The Commission has issued the enclosed Amendments No. 20, 20, and 17 for Licenses No. DPR-38, DPR-47, and DPR-55, for the Oconee Nuclear Station, Units 1, 2, and 3. These amendments consist of changes to the Technical Specifications and are in response to your request dated December 1, 1975, as supplemented February 24 and 27, 1976.

OCONEE NUCLEAR STATION, UNIT 1

AMENDMENT TO FACILITY OPERATING LICENSE

Amendment No. 20
License No. DPR-38

FIGURE 2.1-1A

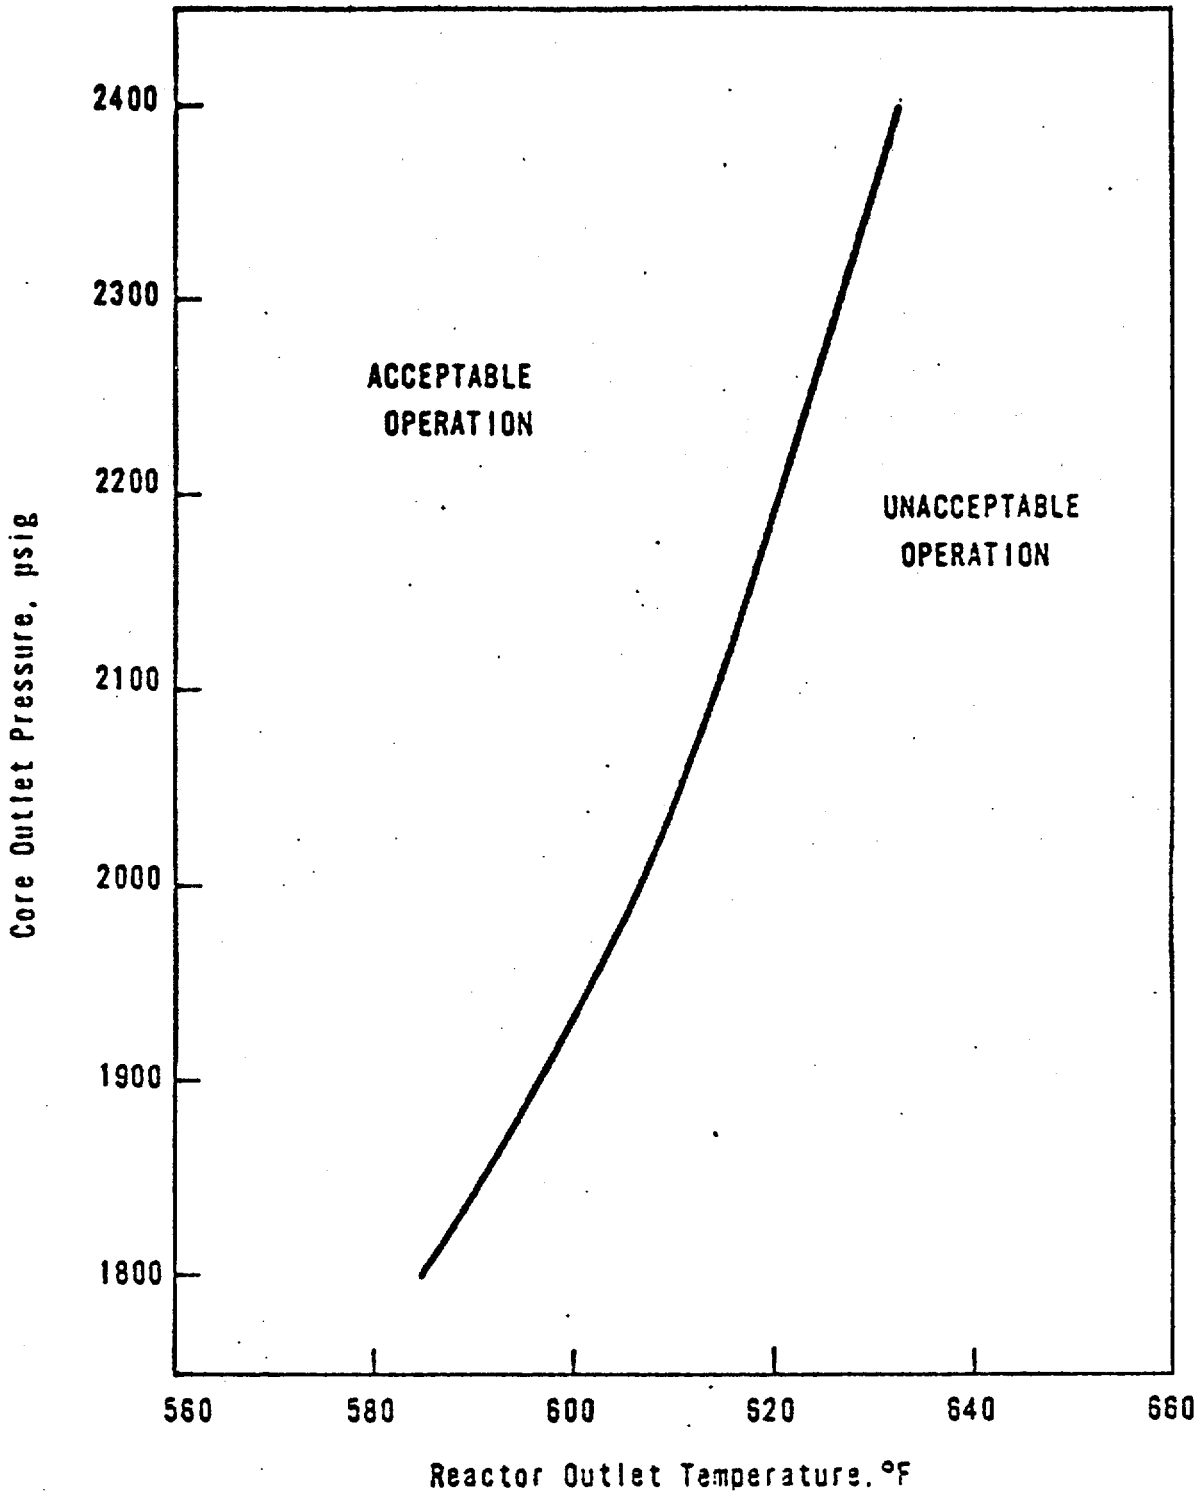
The combination of the reactor system pressure and coolant temperature shall not exceed the safety limit as defined by the locus of points established in Figure 2.1-1A-Unit 1. If the actual pressure/temperature point is below
2.1-1B-Unit 2
2.1-1C-Unit 3
and to the right of the line, the safety limit is exceeded.

The curve presented in Figure 2.1-1A represents the conditions at which a minimum DNBR of 1.30 is predicted for the maximum possible thermal power (112 percent) when four reactor coolant pumps are operating (minimum reactor coolant flow is 107.6 percent of 131.3 x 10^6 lbs/hr.). This curve is based on the combination of nuclear power peaking factors, with potential effects of fuel densification and rod bowing, which result in a more conservative DNBR than any other shape that exists during normal operation.

FIGURE 2.1-2A

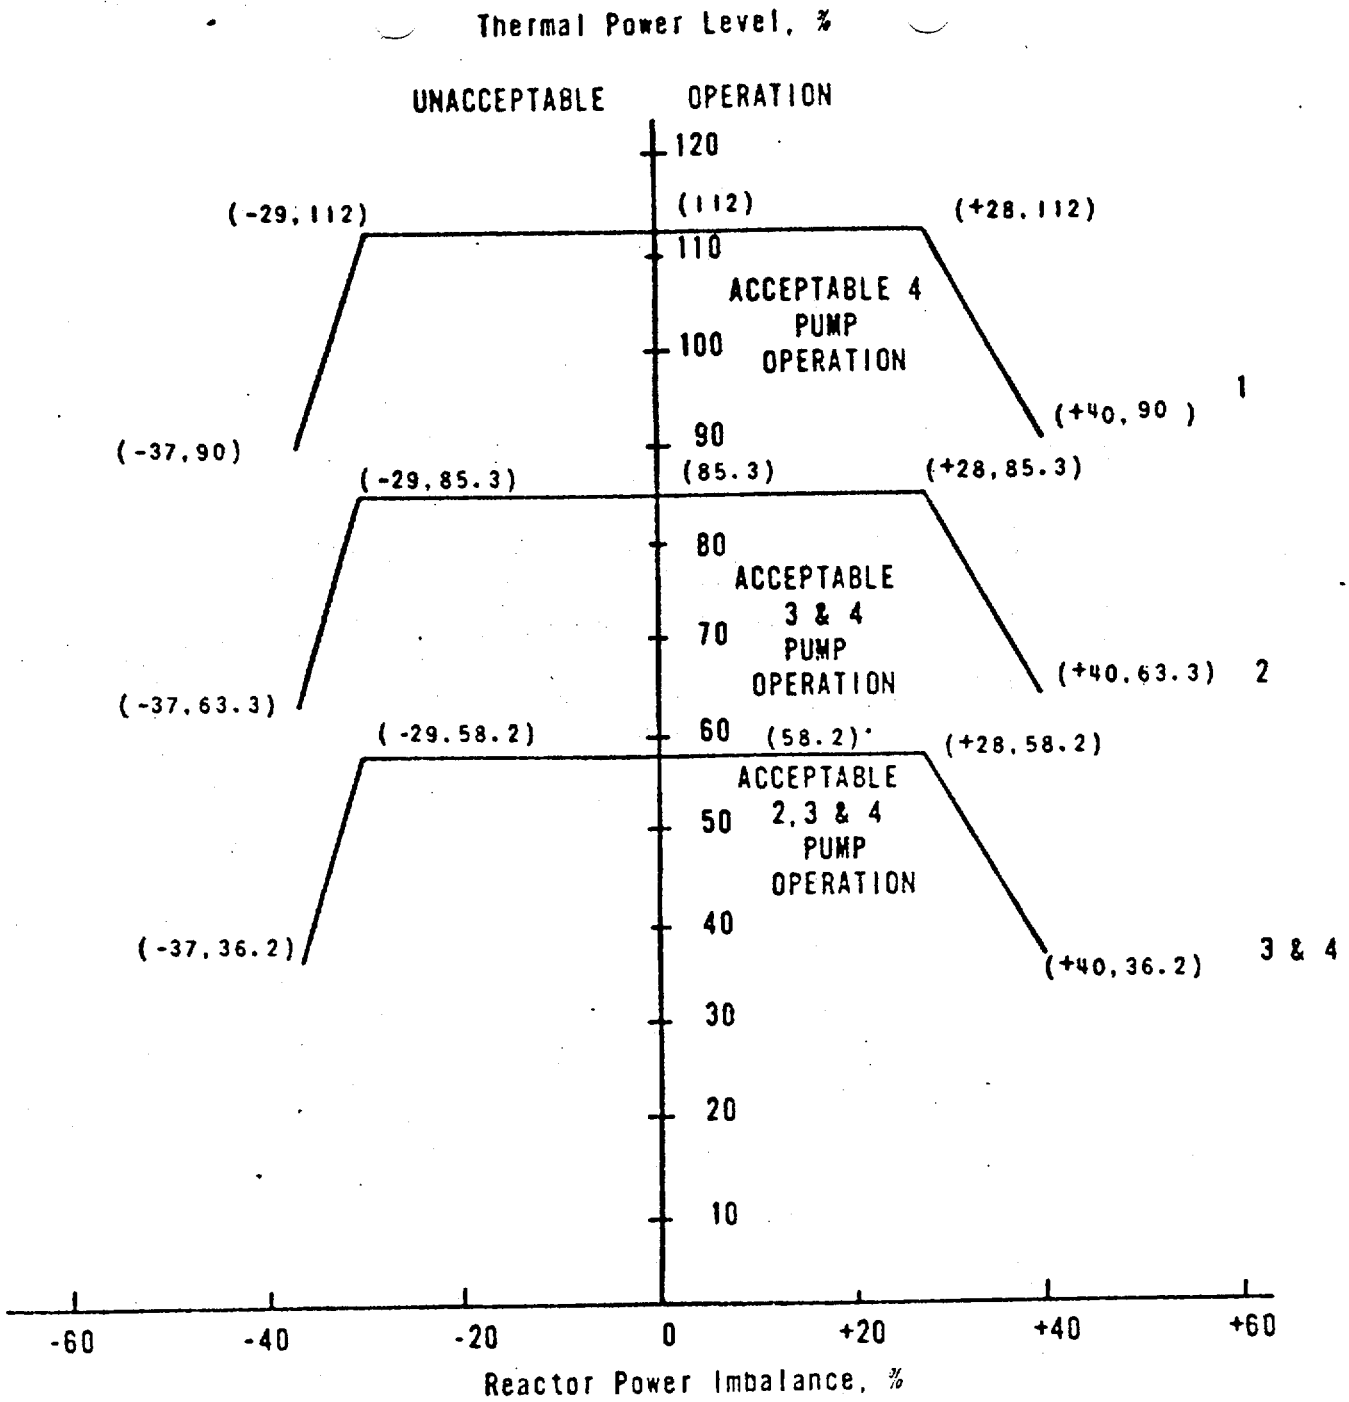
The curves of Figure 2.1-2A are based on the more restrictive of two thermal limits and include the effects of potential fuel densification and rod bowing:

1. The 1.30 DNBR limit produced by the combination of the radial peak, axial peak and position of the axial peak that yields no less than a 1.30 DNBR.

2. The combination of radial and axial peak that causes central fuel melting at the hot spot. The limit is 20.15 kw/ft for Unit 1.

The specified flow rates for Curves 1, 2, 3 and 4 of Figure 2.1-2A correspond to the expected minimum flow rates with four pumps, three pumps, one pump in each loop and two pumps in one loop, respectively.

UNIT 1
OCONEE NUCLEAR STATION
FIGURE 2.1-3A

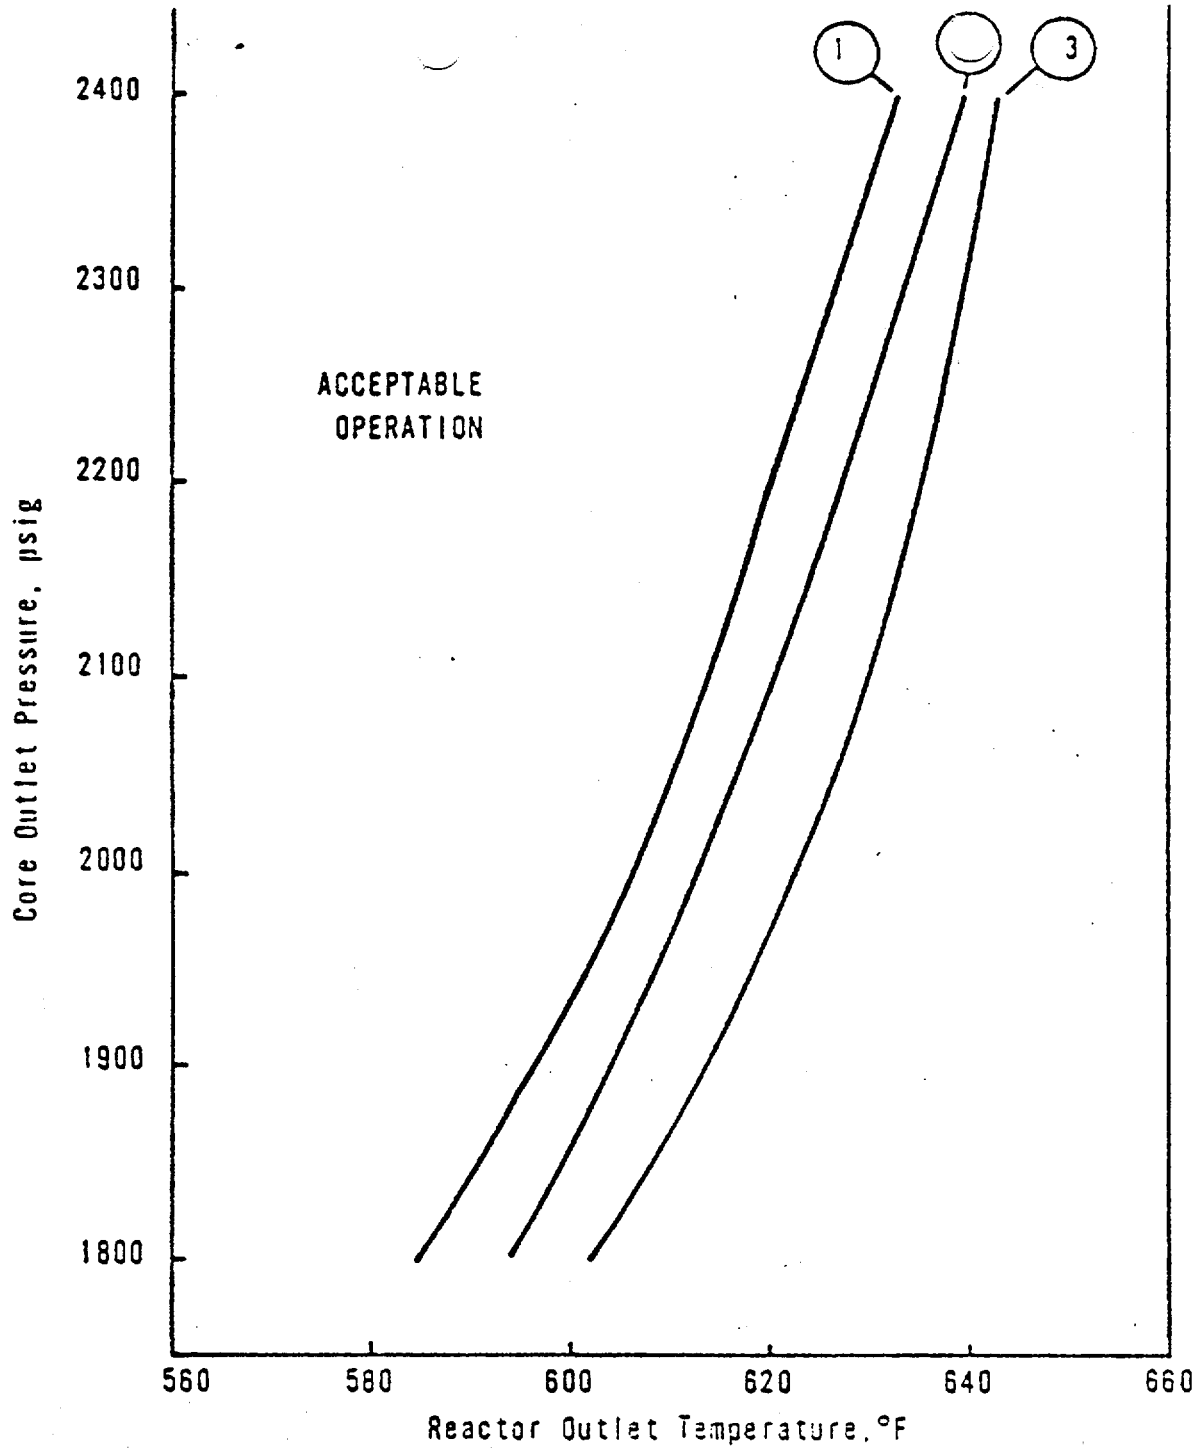
The curve of Figure 2.1-1A is the most restrictive of all possible reactor coolant pump-maximum thermal power combinations shown in Figure 2.1-3A.

For Figure 2.1-3A, a pressure-temperature point above and to the left of the curve would result in a DNBR greater than 1.30. The 1.30DNBR curve for four-pump operation is more restrictive than any other reactor coolant pump situation because any pressure/temperature point above and to the left of the four pump curve will be above and to the left of the other curves.

UNIT 1
PROTECTIVE SYSTEM MAXIMUM
ALLOWABLE SET POINTS
OCONEE NUCLEAR STATION
FIGURE 2.3-1A

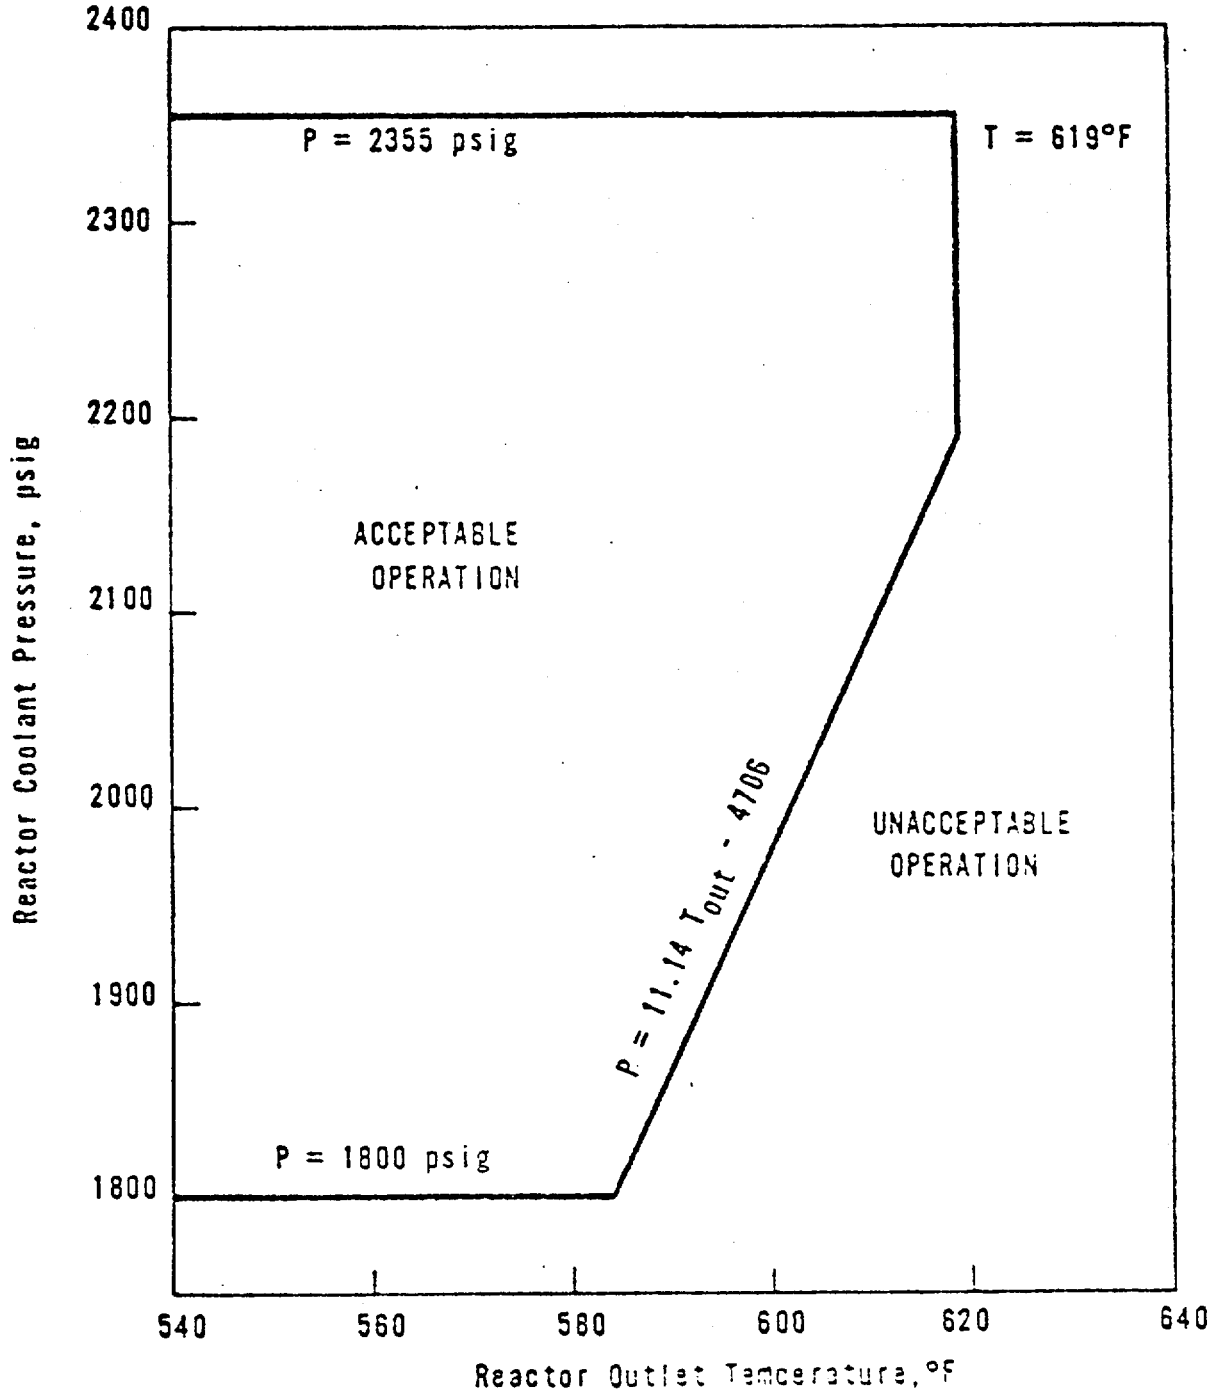
During a startup accident from low power or a slow rod withdrawal from high power, the system high pressure set point is reached before the nuclear overpower trip set point. The trip setting limit shown in Figure 2.3-1A - Unit 1
2.3-1B - Unit 2
2.3-1C - Unit 3
for high reactor coolant system pressure (2355 psig) has been established to maintain the system pressure below the safety limit (2750 psig) for any design transient. (1)

The low pressure (1800) psig and variable low pressure $(11.14\ T_{out} - 4706)$ trip
(1800) psig $(16.25\ T_{out} - 7756)$
(1800) psig $(16.25\ T_{out} - 7756)$
setpoints shown in Figure 2.3-1A have been established to maintain the DNB
2.3-1B
2.3-1C
ratio greater than or equal to 1.3 for those design accidents that result in a pressure reduction. (2,3)

The high reactor coolant outlet temperature trip setting limit (619 F) shown in Figure 2.3-1A has been established to prevent excessive core coolant
2.3-1B
2.3-1C
temperatures in the operating range. Due to calibration and instrumentation errors, the safety analysis used a trip set point of 620°F.

FIGURE 2.3-2A

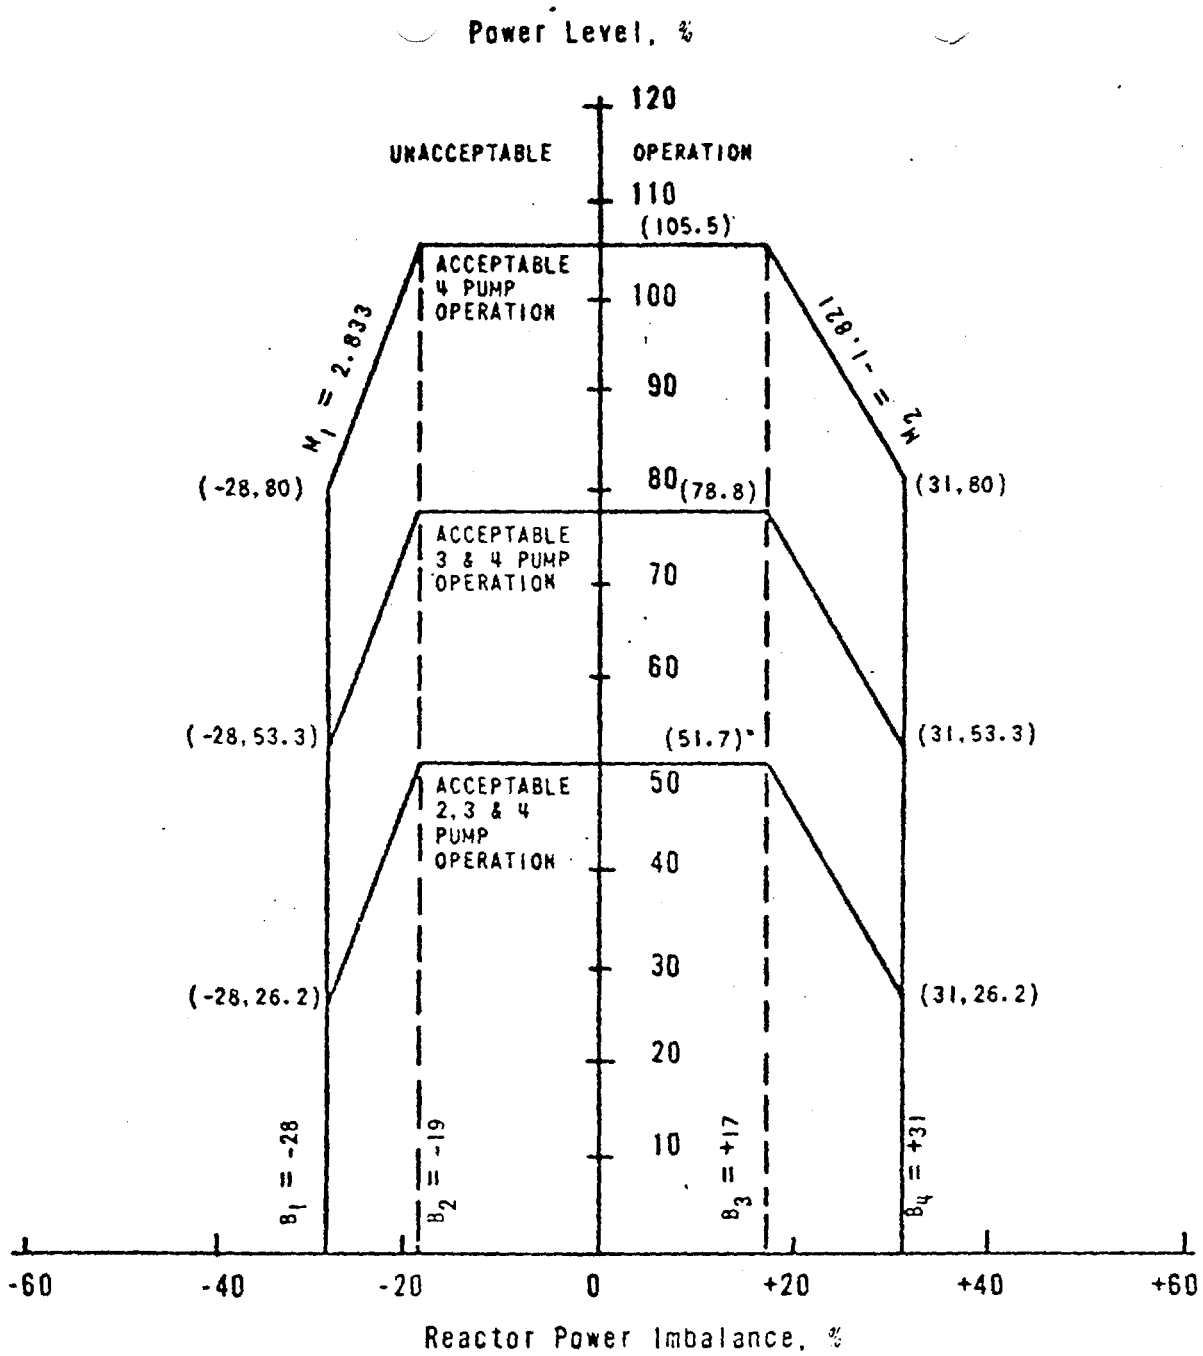
The power-imbalance boundaries are established in order to prevent reactor thermal limits from being exceeded. These thermal limits are either power peaking kw/ft limits or DNBR limits. The reactor power imbalance (power in the top half of core minus power in the bottom half of core) reduces the power level trip produced by the power-to-flow ratio such that the boundaries of Figure 2.3-2A - Unit 1 are produced. The power-to-flow ratio reduces the power
2.3-2B - Unit 2
2.3-2C - Unit 3

level trip and associated reactor power/reactor power-imbalance boundaries by 1.055%-Unit 1 for a 1% flow reduction.
1.07% - Unit 2
1.07% - Unit 3
For Unit 1, the power-to-flow reduction ratio is 0.949, and for Units 2 and 3, the power-to-flow reduction factor is 0.961 during single loop operation.
